ITEM 7.0

CONSIDERATION OF OPTIONS WHICH MAY INCREASE THE NORTHERN SETBACK OF THE TOP LEVEL OF THE BUILDING.

CONCEPT DESIGN - FORM TESTING

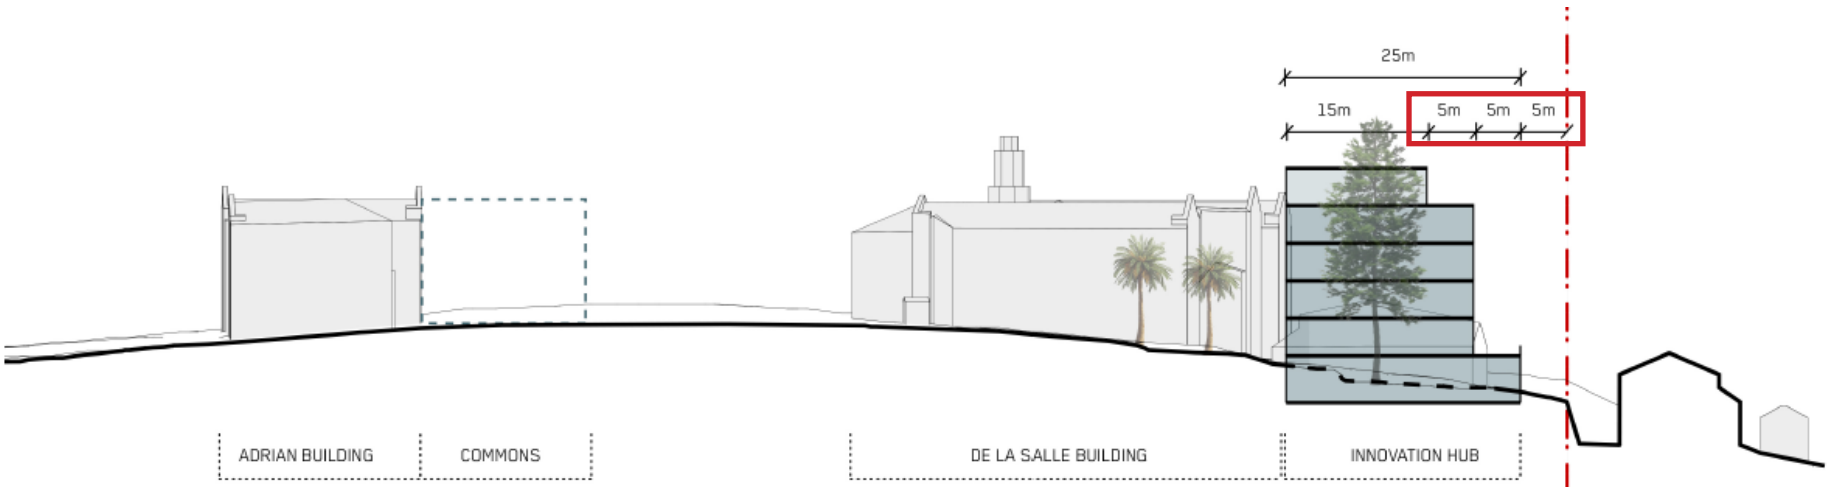
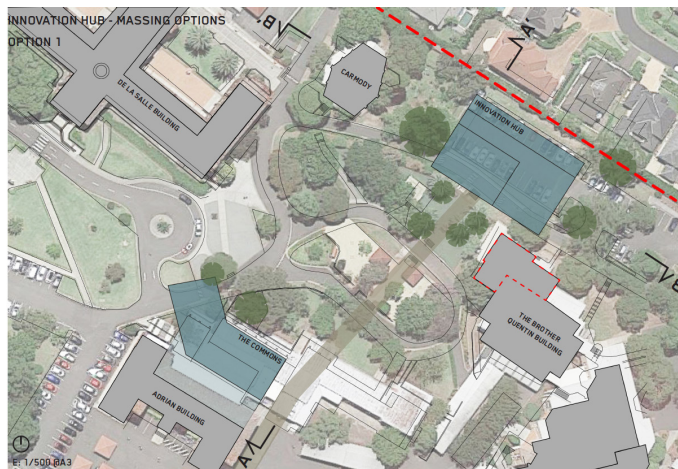
- EARLY CONCEPT DESIGNS (OPTION 1) DEMONSTRATES TESTING OF A STAGGERED SETBACK FORM WHICH INCREASED THE SETBACK OF AS THE BUILDING INCREASED IN HEIGHT. STARTING FROM A 5M SETBACK AT THE LOWER GROUND TO A 10M SETBACK FROM GROUND TO THREE AND A 15M SETBACK ON LEVEL 4.
- THIS OPTION REQUIRED THE BUILDING TO BE 6 STOREYS IN ORDER TO FACILITATE USABLE CLASSROOM SPACES. FOOTPRINT OF BUILDING IS COMPARATIVELY SMALLER, HOWEVER HEIGHT OF BUILDING IN GREATLY INCREASED.

- PROS
- COMPACT FORM REDUCING COST
 - END POINT OF NEW AXIS VISIBLE FROM COMMONS BUILDING
 - HISTORIC BUILDING AXIS CAN BE REINSTATED/RETAINED
 - STAGGERED SET BACKS TO UPPER LEVELS
- CONS
- TOO HIGH COMPARED TO SITE, NEIGHBOURING RESIDENTS AND HERITAGE BUILDING
 - OFFENSIVE / CONTROVERSIAL TO NEIGHBOURING RESIDENTS
 - NO INTERACTION WITH SITE
 - TOP FLOORS DISCONNECT FROM CAMPUS

CONCEPT DESIGN - FORM TESTING

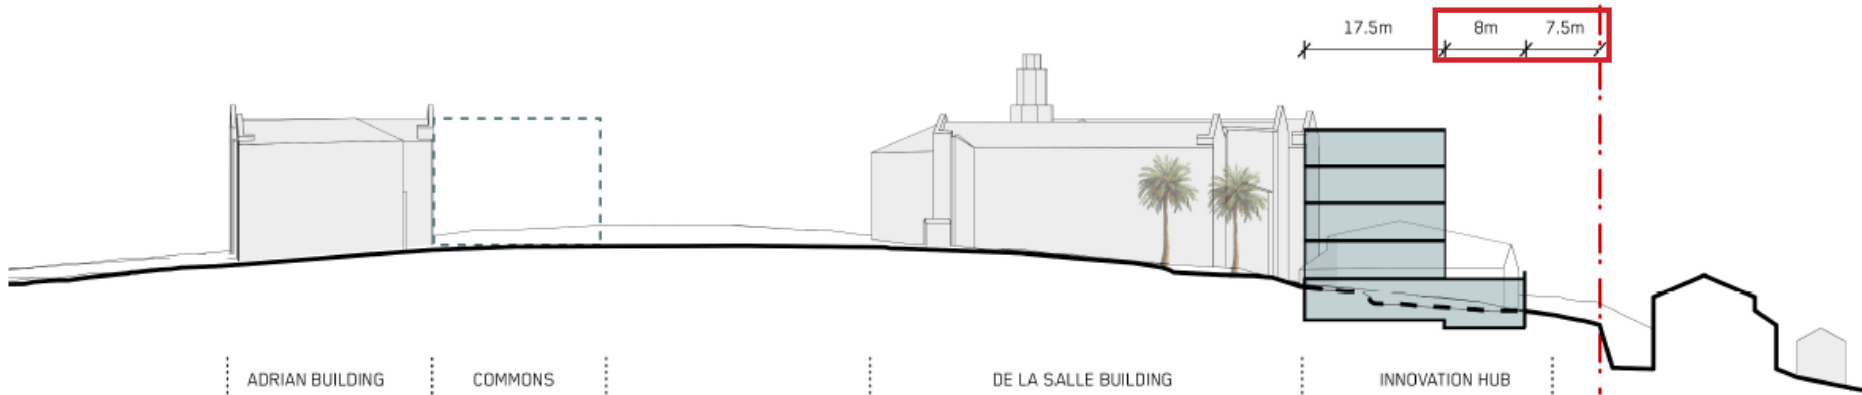
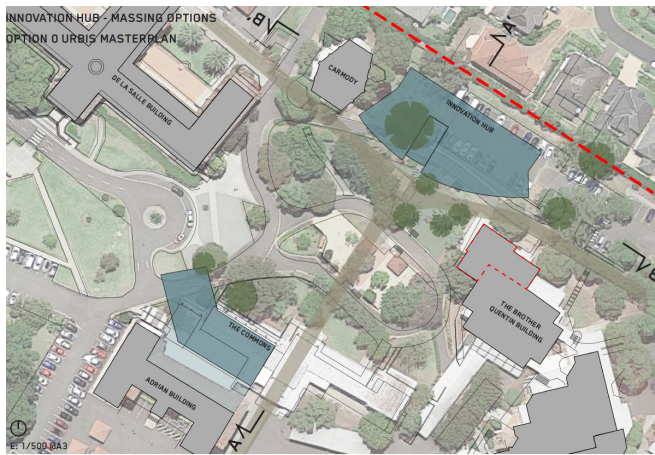
- THE MASTERPLAN OPTION HAD LOOKED AT HAVING 7.5 METRE SETBACK FROM LOWER GROUND AND 15.5 METRE SETBACK TO UPPER LEVELS.
- THIS OPTION HAD LARGER FOOTPRINT AND ALSO LARGER FRONTAGE TO NORTHERN NEIGHBOURS
- HEIGHT OF THIS OPTION WAS STILL DEEMED TO HIGH IN COMPARISION TO SURROUNDING CONTEXT
- LARGE BUILDING FRONTAGE TO NORTHERN BOUNDARY

- PROS
- END POINT OF NEW AXIS VISIBLE FROM COMMONS BUILDING
 - TOTAL HEIGHT DOES NOT EXCEED HERITAGE BUILDINGS
 - MATURE GUM TREES CAN BE RETAINED BENEFITING RESIDENTS AND SCHOOL
- CONS
- PINE TREE OF SIGNIFICANT HERITAGE VALUE NEEDS TO BE TAKEN DOWN
 - STEPS OF SIGNIFICANT HERITAGE VALUE NEED TO BE TAKEN DOWN
 - NEW AXIS DISREGARDS HISTORIC "KINKED" AXIS TO OLD COX BUILDING
 - 5 STOREY HIGH BUILDING COMPROMISES VIEW AMENITY AND PRIVACY OF NEIGHBOURING RESIDENTS

CONCEPT DESIGN - FORM TESTING

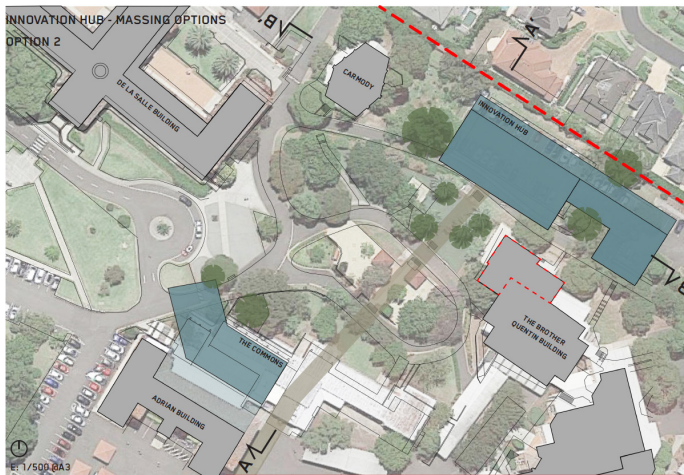
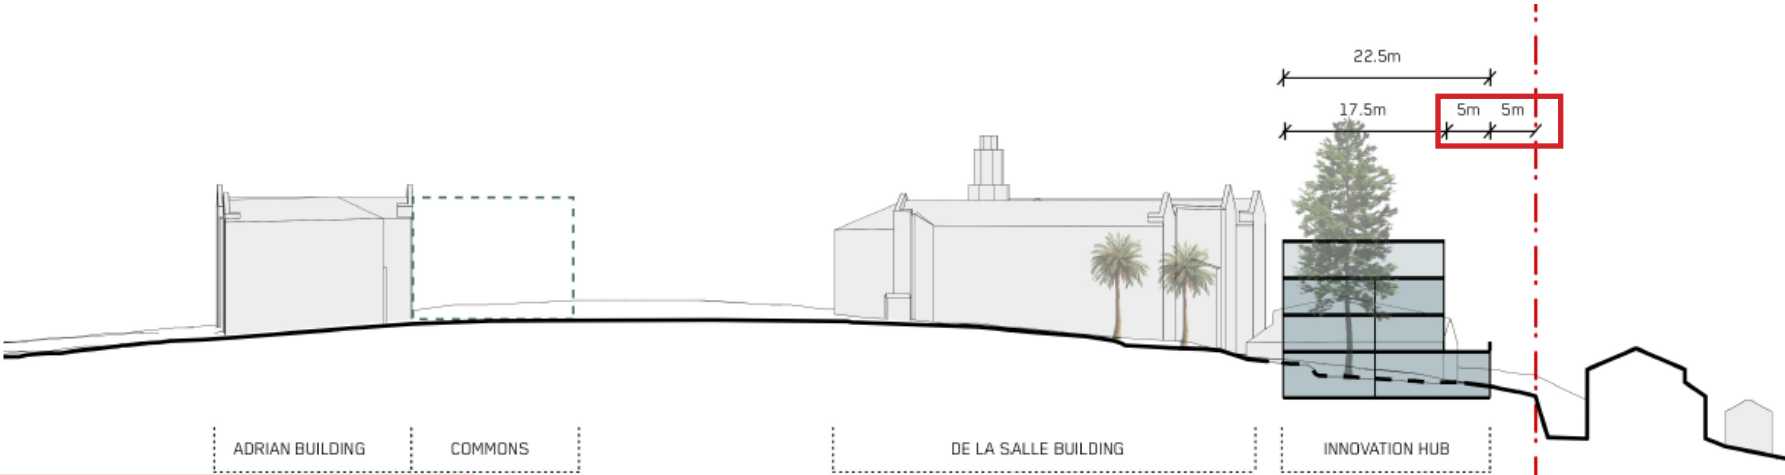
- THE 4 STOREY OPTION WAS TESTED WITH 5M SETBACK FOR LOWER GROUND AND 10M SETBACK FOR UPPER LEVELS
- FOOTPRINT OF THE BUILDING WAS INCREASED TO ACCOMODATE A LOWER OVERALL BUILDING HEIGHT
- LARGE BUILDING FRONTAGE TO NORTHERN BOUNDARY

- PROS
- PINE TREE OF SIGNIFICANT HERITAGE VALUE RETAINED
 - REDUCTION OF HEIGHT TO 3-4 STOREYS
 - COURTYARD SPACE BENEFITS (OUTDOOR SPACE AND LIGHT TO INTERNAL SPACES)
- CONS
- LARGER FOOTPRINT
 - DEMOLITION OF SMALL PORTION OF ADJACENT "BROTHER QUENTIN BUILDING" (POTENTIALLY)
 - LARGE NORTHERN FRONTAGE OF UPPER LEVELS

PROPOSED CONCEPT DESIGN FORM

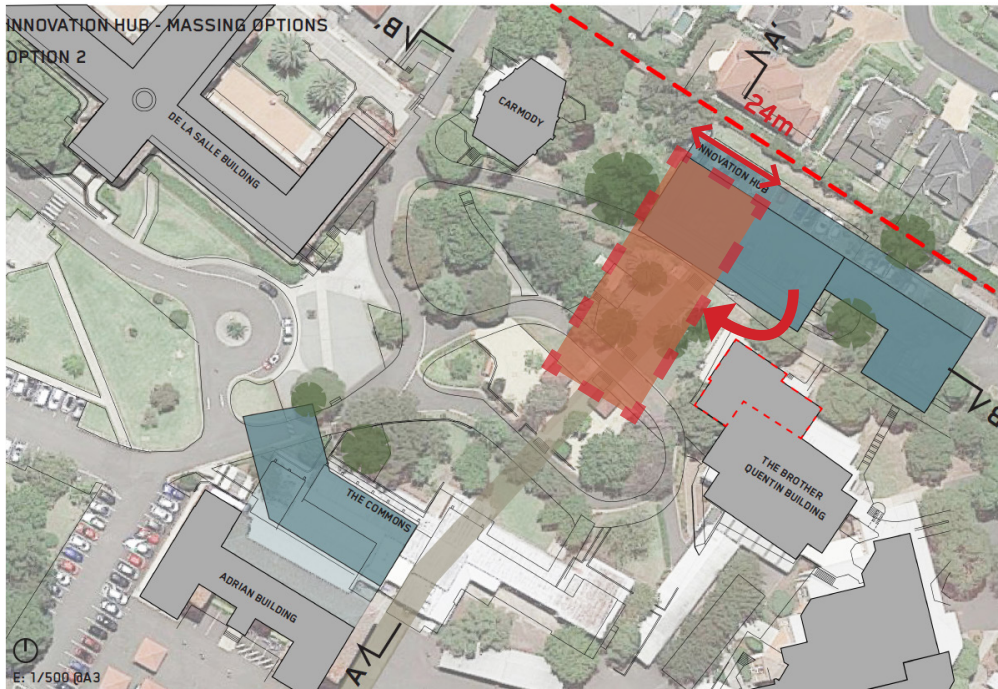
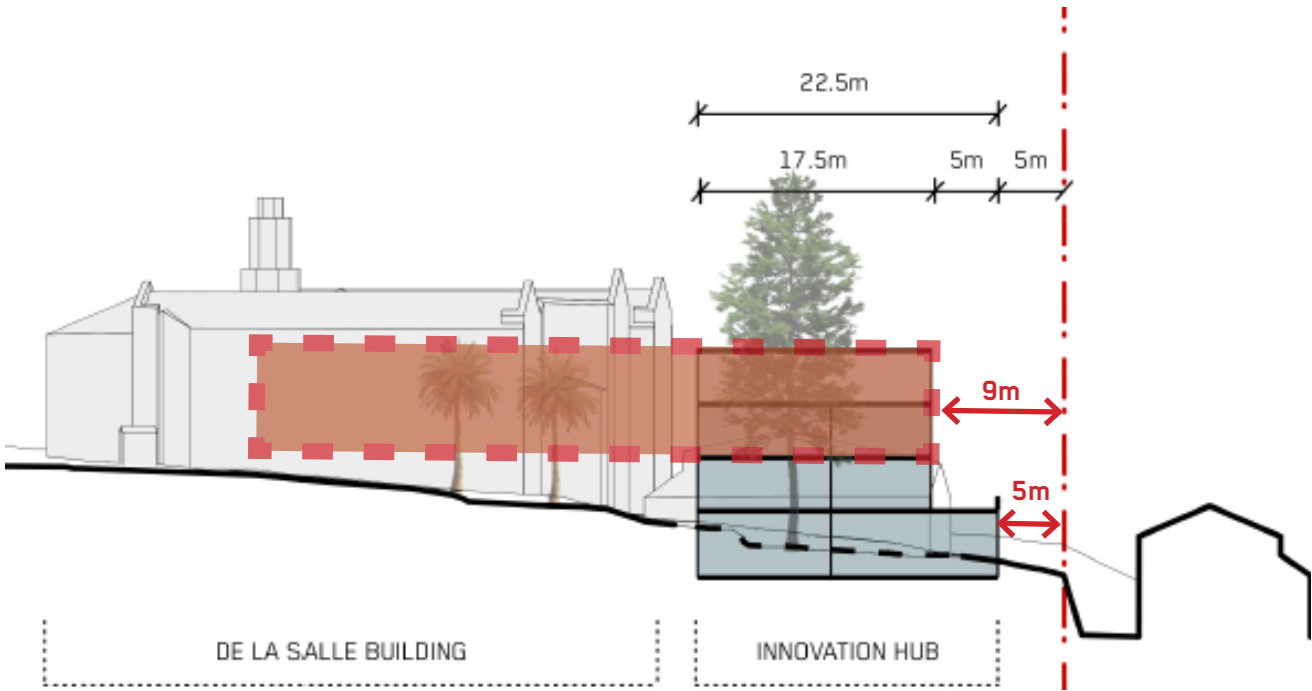
- THE UPPER LEVELS WERE PROPOSED TO BE ROTATED 90 DEGREES TO REDUCE FRONTAGE TO NORTHERN BOUNDARY
- MAINTAINED EXISTING CEREMONIAL WALK ON GROUND LEVEL
- REDUCED HEIGH AND REDUCED NORTHERN FRONTAGE DESIGN ALLOWED FOR LESS VISUAL IMPACT TO NEIGHBOURS

MAINTAINING THE EXISTING CEREMONIAL WALK AXIS

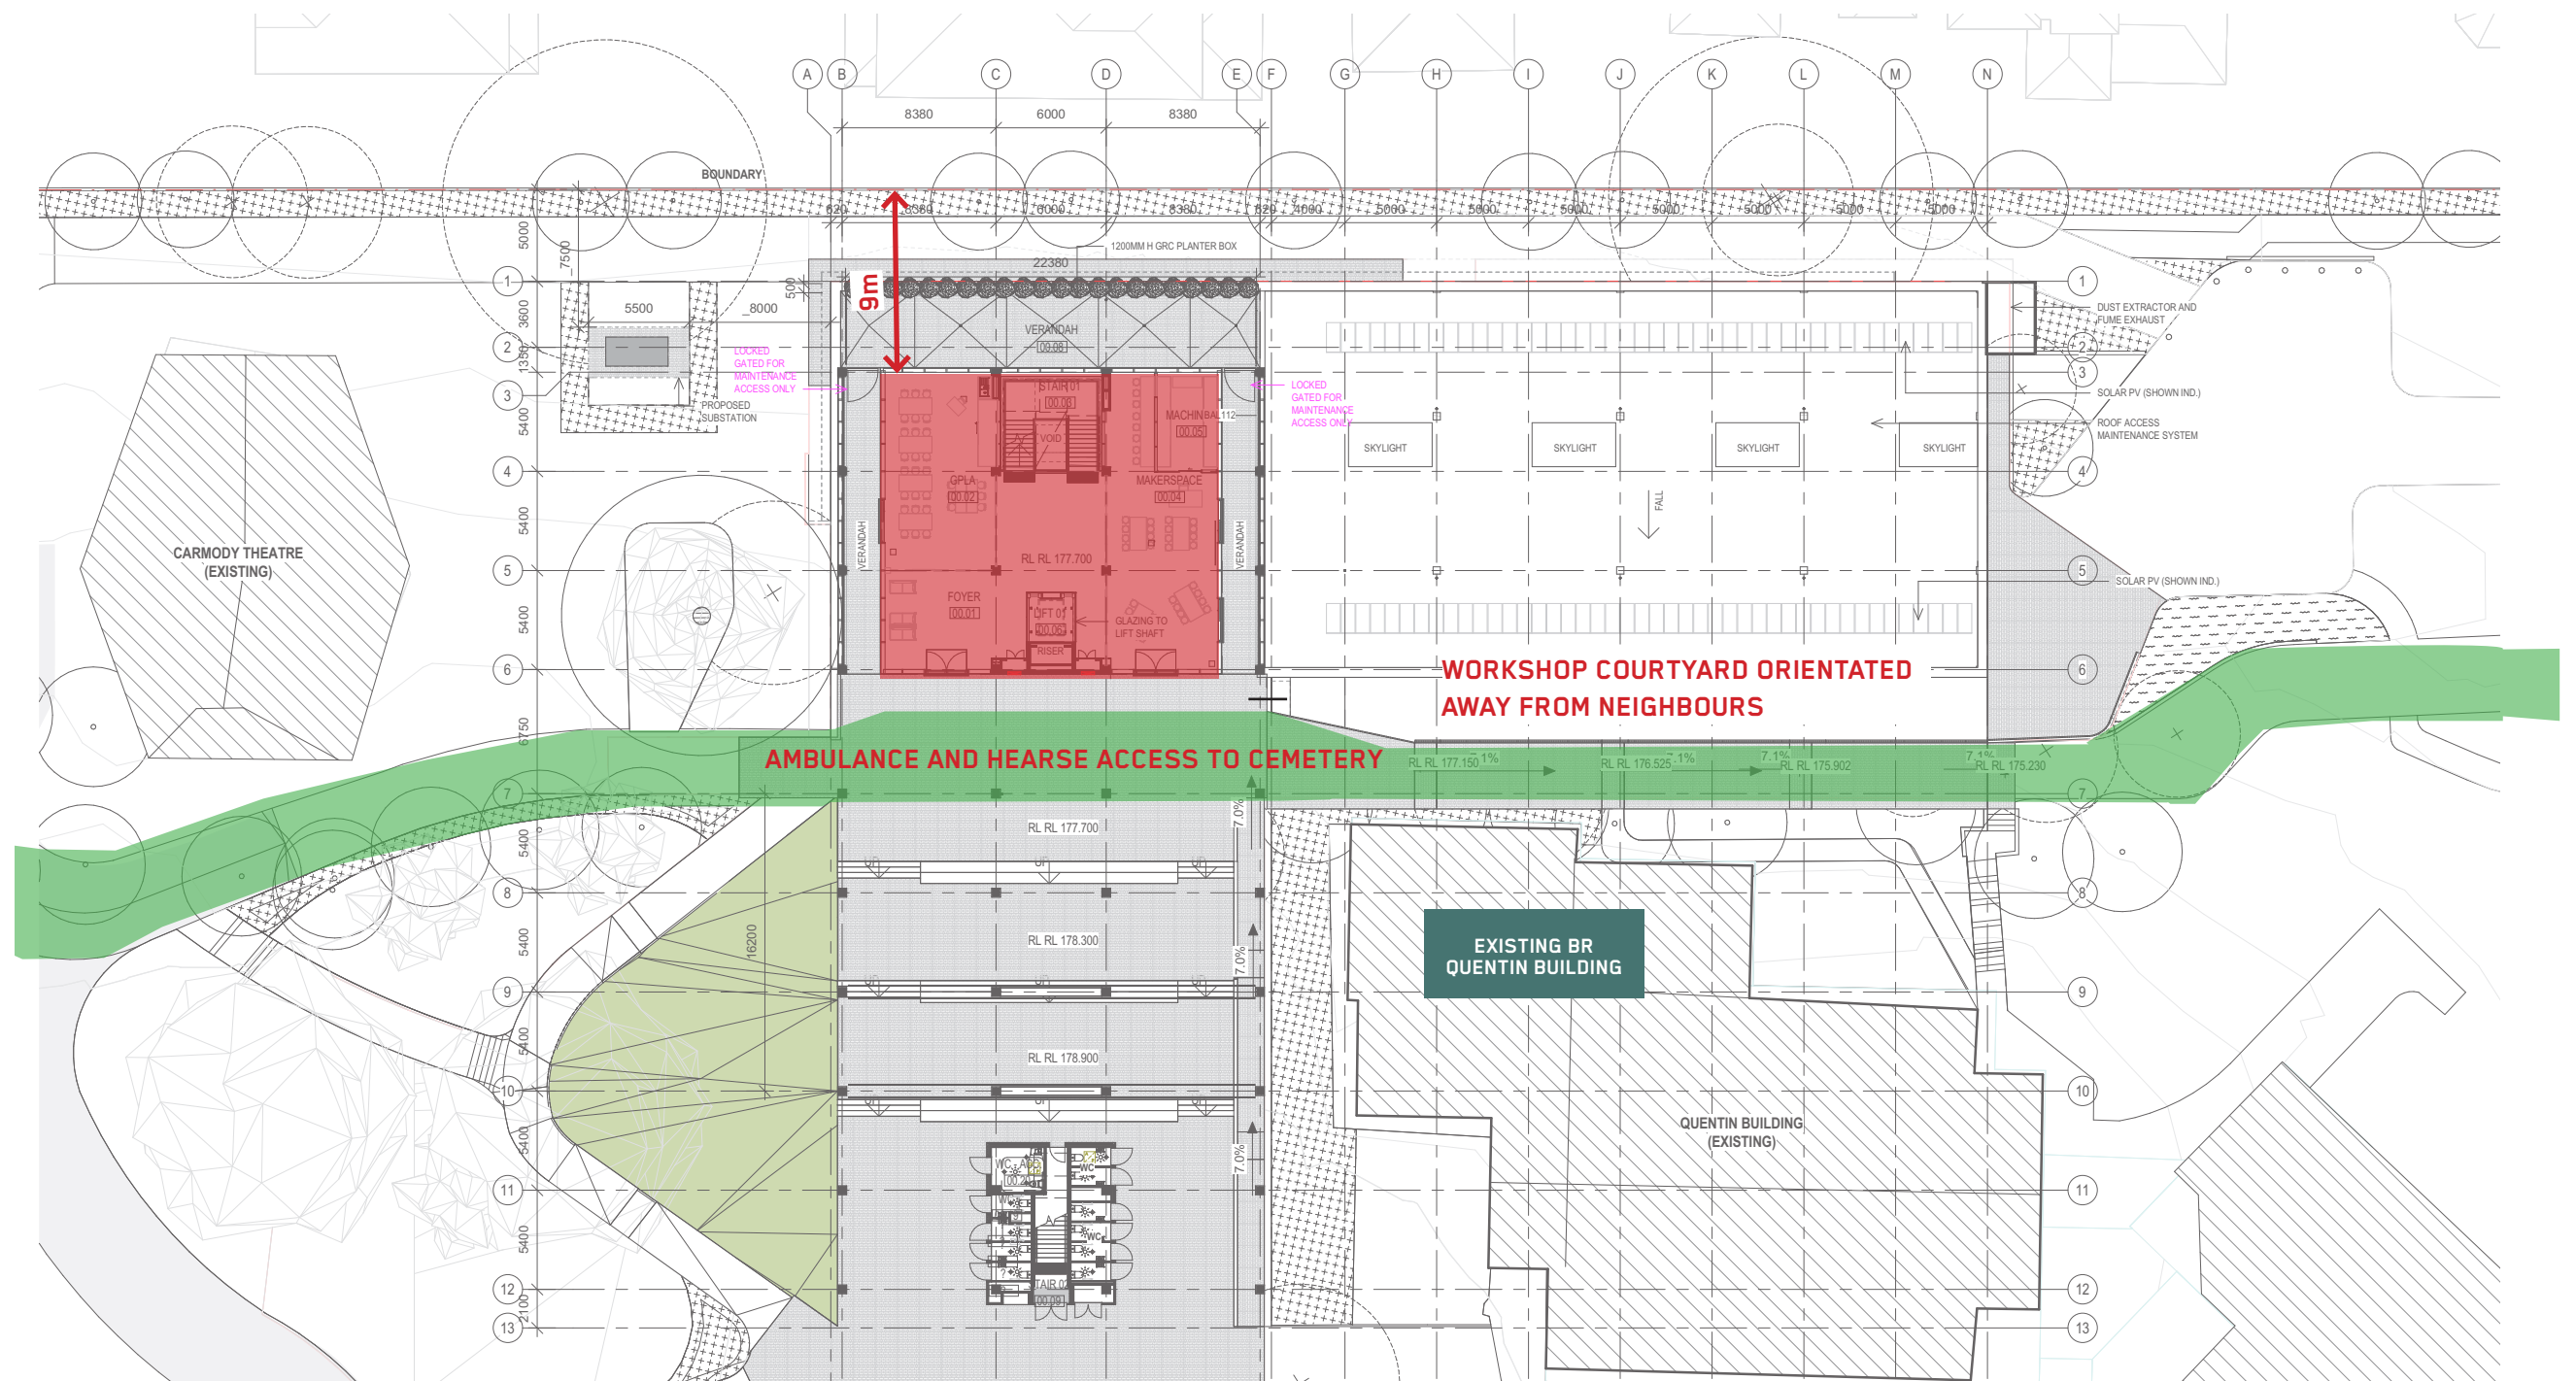
- THE EXISTING CEREMONIAL WALK TOWARDS TO CEMETERY WAS MAINTAINED TO PROVIDE PEDESTRIAN CONNECTION THROUGHOUT THE CAMPUS WHILST ALLOWING ENTRY PROCESSIONS TO BE CONDUCTED BY THE COLLEGE IN THE EVENT OF A FUNERAL SERVICE.
- CEREMONIAL WALK REQUIRES VEHICULAR ACCESS AND MINIMUM SWEEPED PATHS
- WORKSHOPS ON LOWER GROUND OPEN AWAY FROM NORTHERN BOUNDARY TO REDUCE NOISE
- MOVING THE CEREMONIAL WALK SOUTH WOULD NOT BE POSSIBLE TO LOCATION EXSTING BR QUENTIN BUILDING, WORKSHOP COURTYARD ORIENTATION AND VEHICULAR ACCESS REQUIRED ON SITE.
